UNITED STATES PATENT AND TRADEMARK OFFICE

APPLICATION NO.	FILING DATE	FIRST NAMED INVENTOR	ATTORNEY DOCKET NO.	CONFIRMATION NO.
10/565,469	01/19/2006	Tobias Melz	1033832-000013	9936

DETAILED ACTION

第 3 図

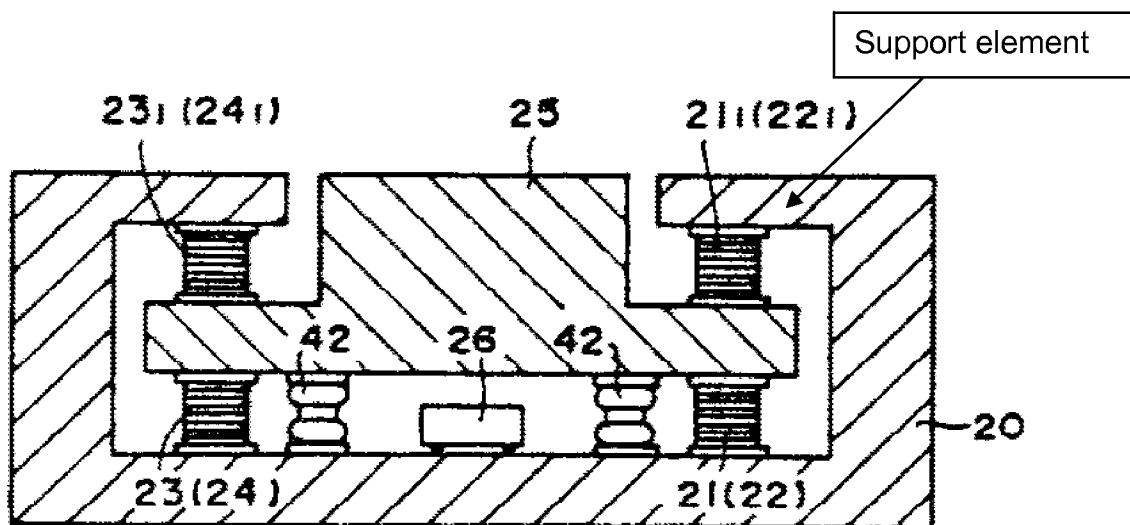
Re: claim 10, Katsumi shows an interface for reducing mechanical vibrations, as in the present invention, which has a base connection element 20, a load connection element 25 and at least one support element, as marked below, a) wherein at least a first energy converter system, 21, 23 bottom, extends between at least one engagement point located on the base connection element and at least one engagement point located on the load connection element; b) wherein at least one second energy converter system, 21, 23 top, extends between at least one engagement point located on the support element and at least one engagement point located on the load connection element; and d) wherein the load connection element 25 has a part located in an intermediate space between the base connection element and the support element, and a part located outside the intermediate space between the base connection element and the support element, as shown in figure 3. Katsumi lacks the elastic pipe surrounding the actuators as claimed. Sasaki shows an elastic pipe 14 for a vibration damper in figure 1 in order to provide further dampening capability to the

bearing body 13 at the same time to protect body 13 from environmental elements. It would have been obvious to one of ordinary skill in the art at the time the invention was made to have modified Katsumi's assembly to comprise an elastic pipe as taught by Sasaki in order to provide further dampening capability to the assembly of Katsumi at the same time protecting the assembly from environmental elements.
